PROJECT: C-8625  
SR 520 West Approach Bridge North Project

SUBJECT: **CO # 72 – Marine Casing Ext and Misc**

**WASHINGTON STATE  
DEPARTMENT OF TRANSPORTATION  
CHANGE ORDER**

CONTRACT NO: 008625 FEDERAL AID NO: BR-NHPP-0520 (053)  
CONTRACT TITLE: SR 520, MONILAKE TO EVERGREEN PT. BRIDGE WEST APPR  
CHANGE ORDER NO: 72 MARINE CASING EXT AND MISC

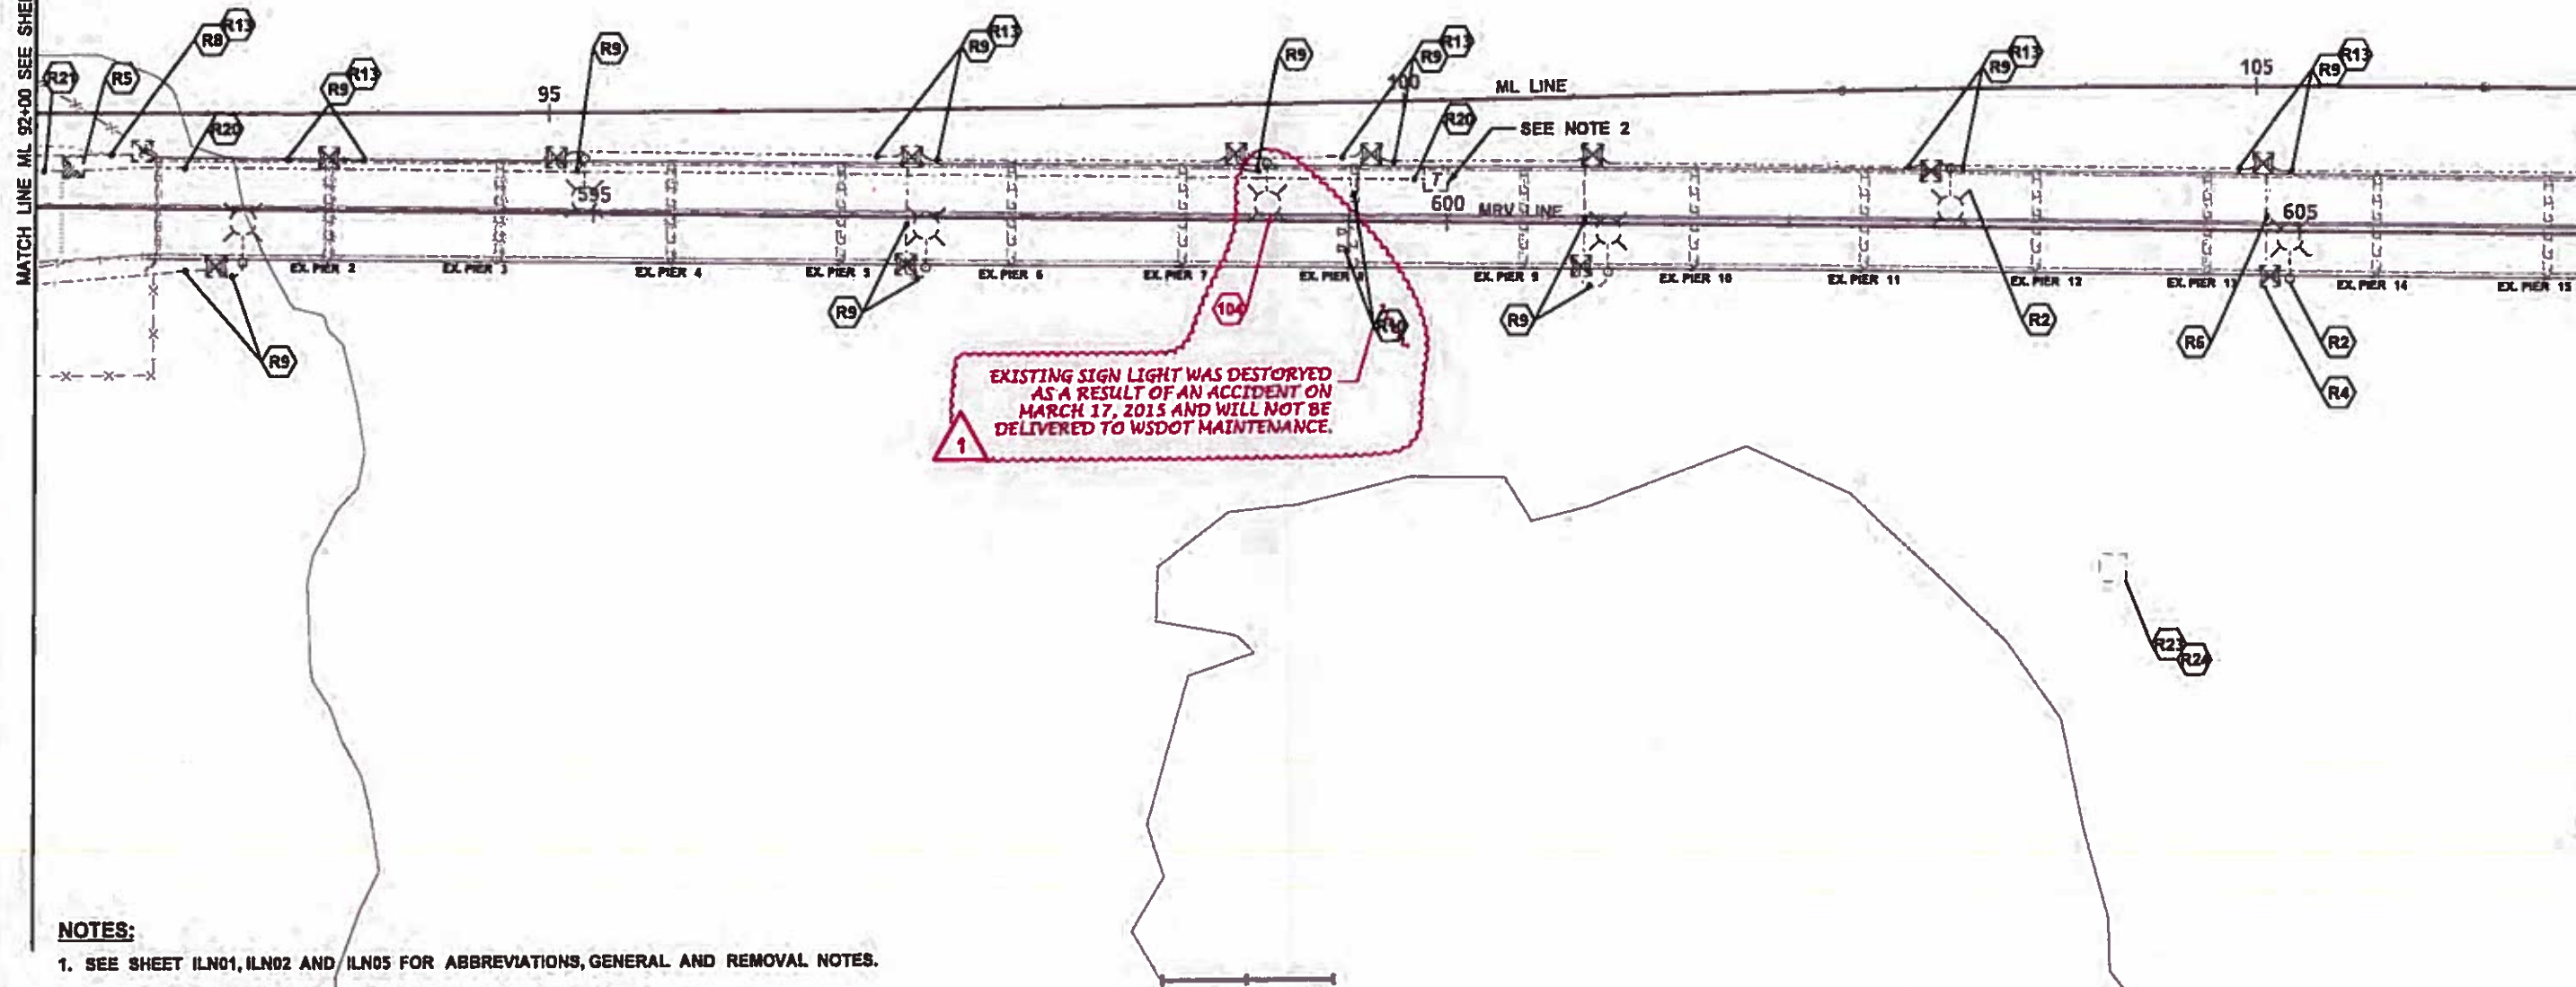
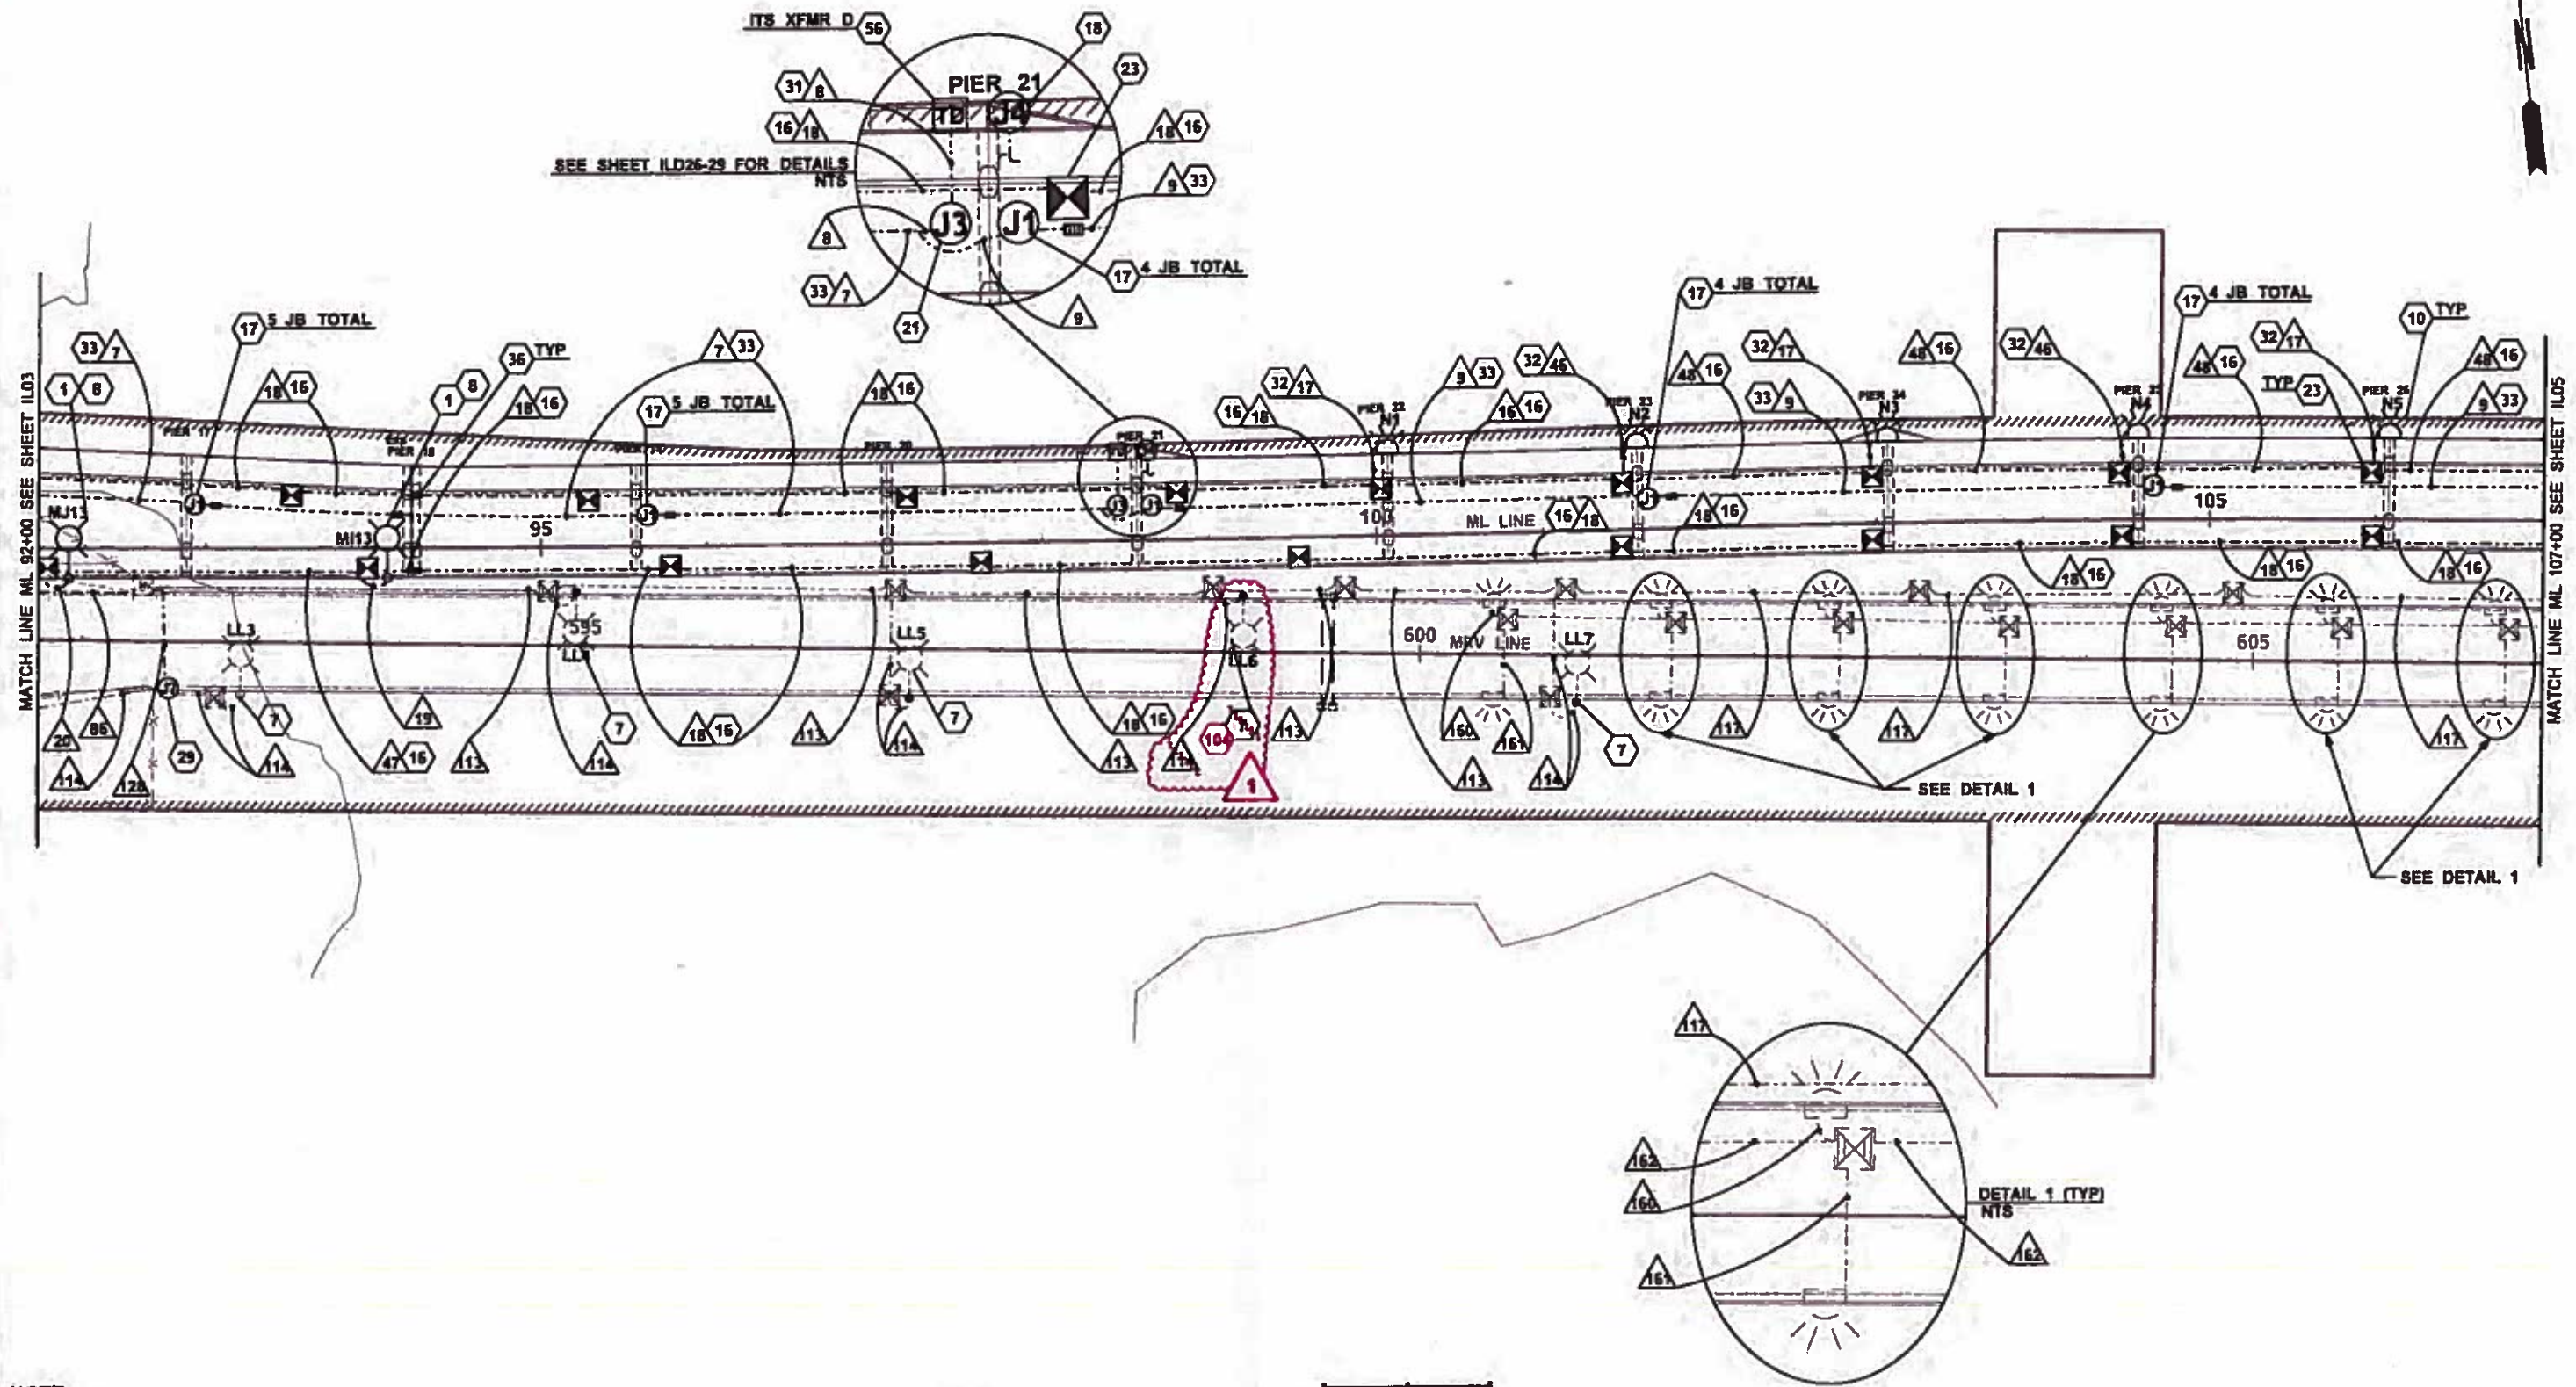
Plan Sheets IIN03a titled "Illumination General Notes & Legend", IIR04 titled "Illumination Removal Plan", ILO4 titled "Illumination Plan", IID03 and IID10 both titled "Illumination Details", TSN06 and TSN09 titled "ITS Wiring Schedule", TS07 titled "ITS Plan" and TSD02, TSD16 and TSD17 all titled "ITS Details" are deleted and replaced with pages 7 through 17 of this change order.

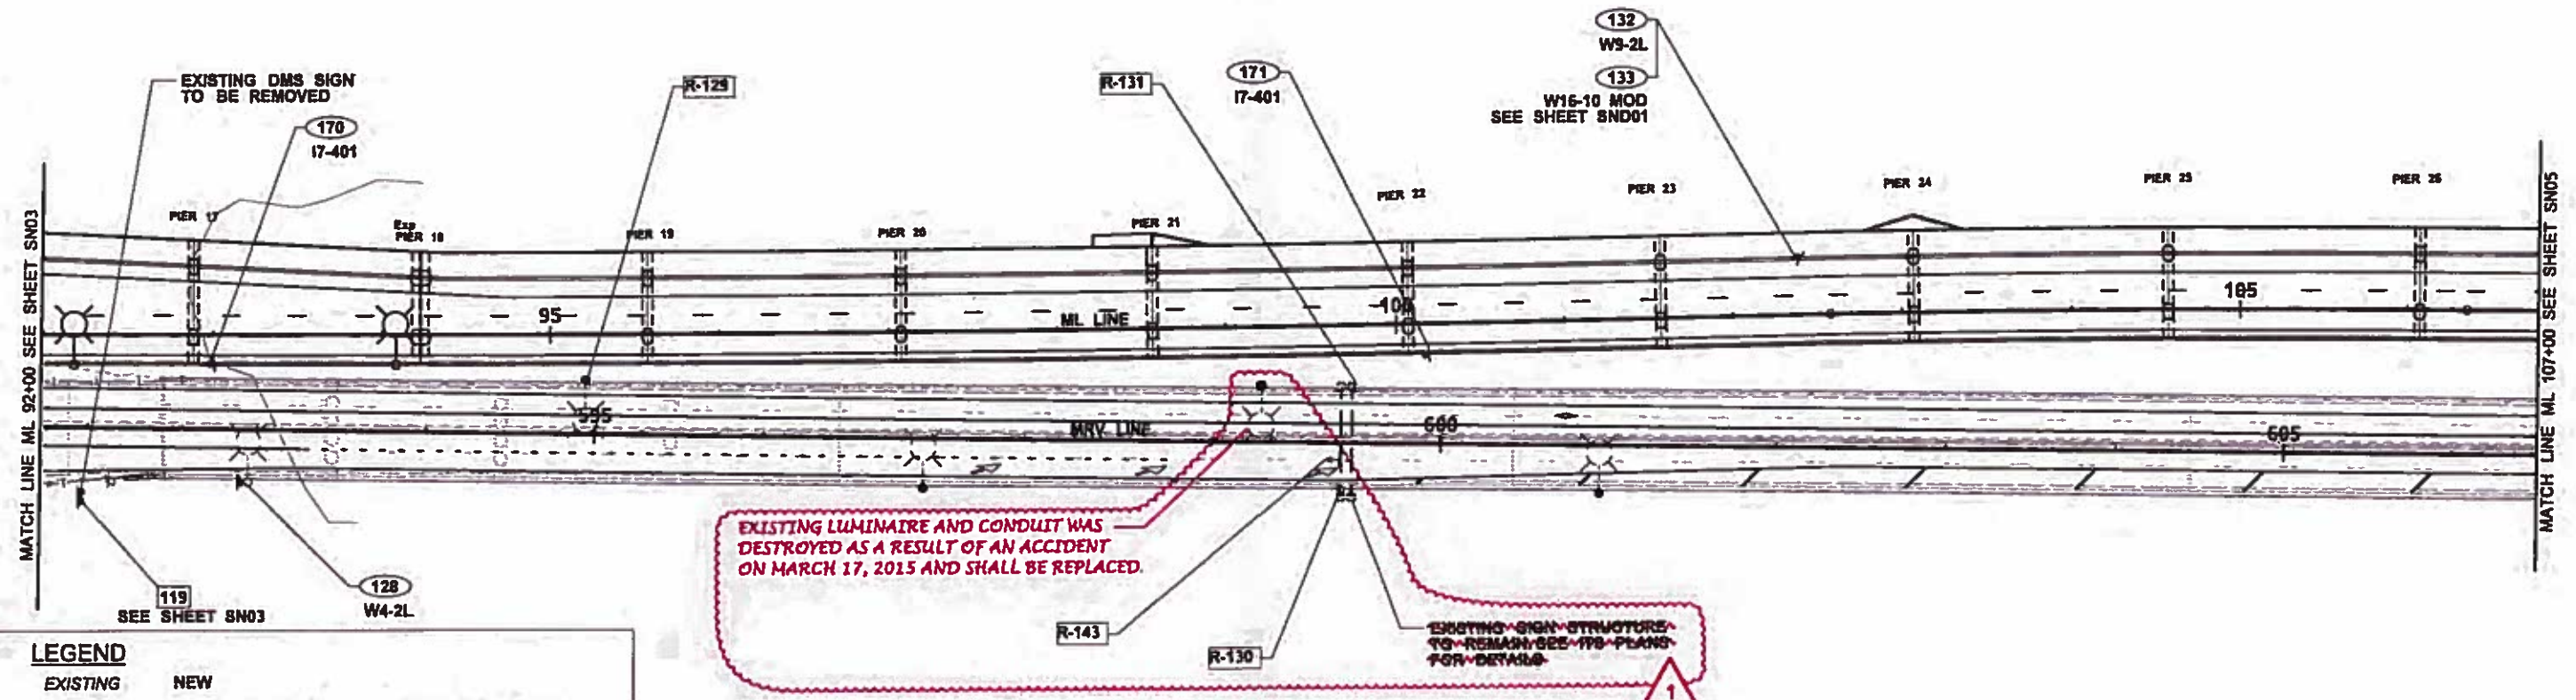
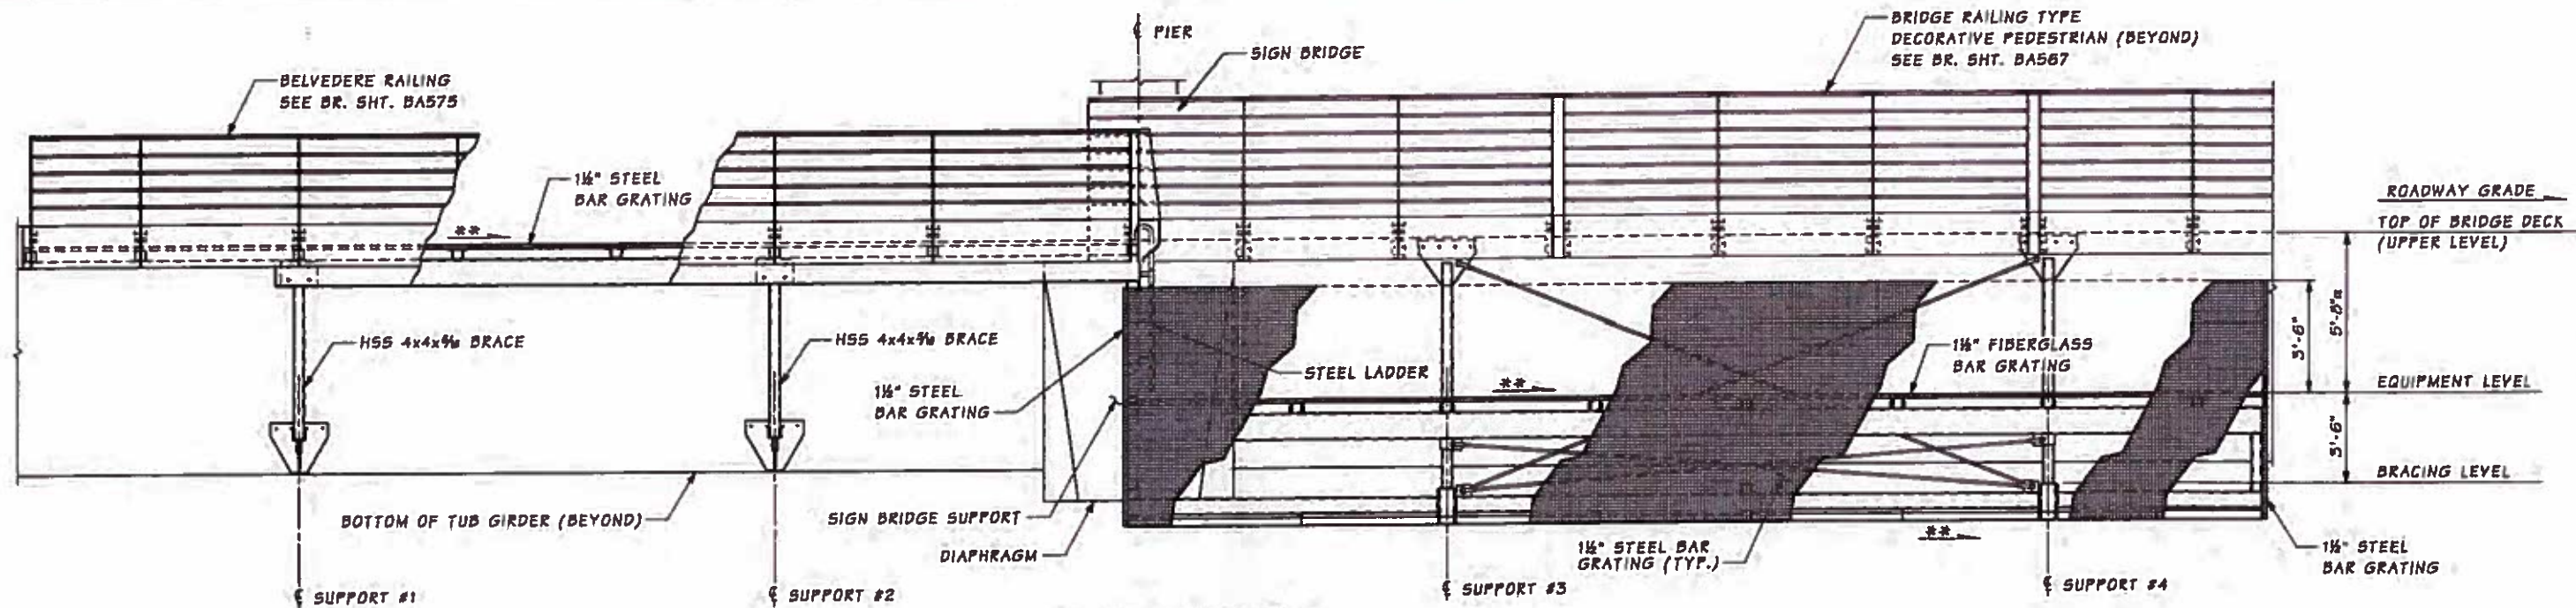
Plan Sheet SN04 titled "Sign Plan" is deleted and replaced with page 18 of this change order.
